This bulletin supersedes TSB JLRTB02040NAS1/2020 dated 26 MAY 2020, which should either be destroyed or clearly marked to show it is no longer valid (e.g. with a line across the page). Only refer to the electronic version of this Technical Bulletin in TOPIx.

418-00

Heated Tailgate Window Inoperative

4.

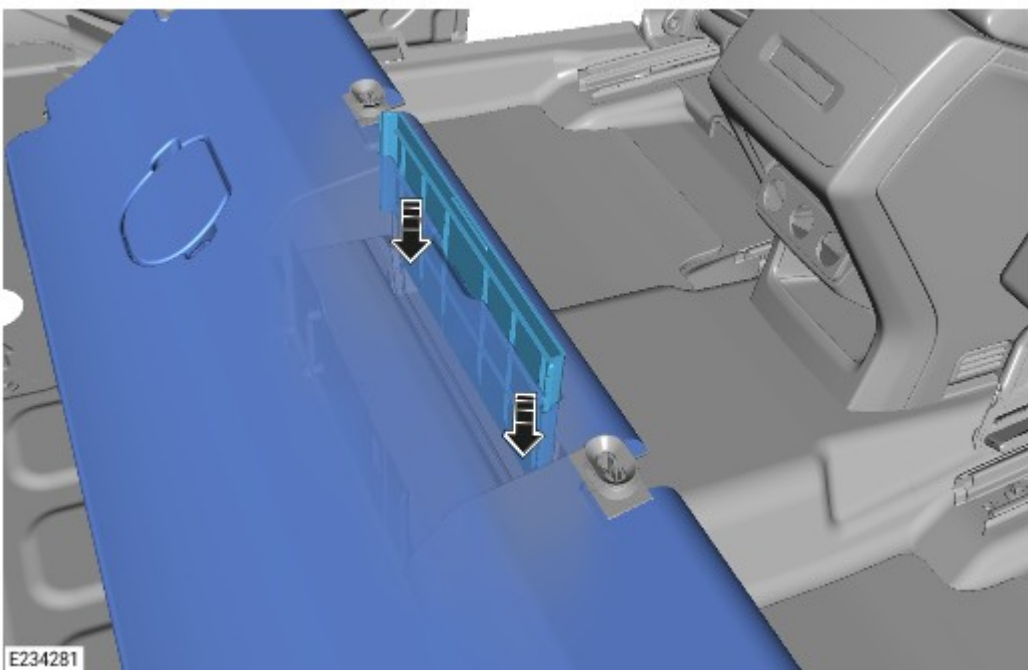
The heated tailgate window is inoperative when the switch is in the ON position. Further investigation has found that fuse F17 in the Passenger Junction Box (PJB) has blown.

Operating current higher than expected.

Remove and discard fuse F17 from the PJB.

- Install the new 30A mini fuse in F17 of the PJB.
